TECHNICAL EVALUATION REPORT

**PRIMARY COOLANT SYSTEM
PRESSURE ISOLATION VALVES**

NORTHERN STATES POWER COMPANY
PRAIRIE ISLAND UNITS 1 AND 2

October 24, 1980

Figure 1. Valve Configurations Designated by the NRC To Be Included in This Technical Evaluation

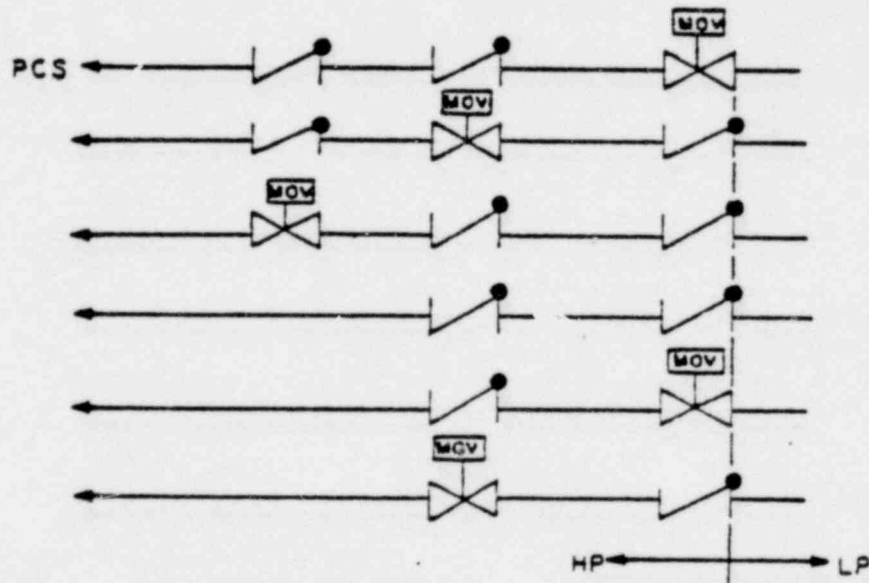
- 1) The high-pressure system must be connected to the Primary Coolant System;
- 2) there must be a high-pressure/low-pressure interface present in the line;
- 3) this same piping must eventually lead outside containment;
- 4) the line must have one of the valve configurations shown in Figure 1; and
- 5) the pipe line must have a diameter greater than 1 inch.

It has been determined that the Low-Pressure Safety Injection/Residual Heat Removal System in Prairie Island Units 1 and 2 incorporates valving in one of the configurations (identified in Figure 1) designated by the NRC as a valve configuration of concern. Moreover, based on the previously docketed information and drawings made available for FRC review, FRC found that the crossover line between the Loop B cold-leg Accumulator and the Low-Pressure Safety Injection/Residual Heat Removal system lines also incorporates a valve configuration of concern. Thus, if the licensee's review of the valving configuration contained in this crossover line confirms FRC's finding, then valve configurations of concern exist in two systems of Prairie Island Units 1 and 2, incorporating the valves listed in Table 1.0.

If NSP modifies the Plant Technical Specifications for Prairie Island Units 1 and 2 to incorporate periodic testing (as delineated in Section 2.2) for the check valves itemized in Table 1.0, then FRC considers this an acceptable means of achieving plant compliance with the NRC staff objectives of Reference 1.
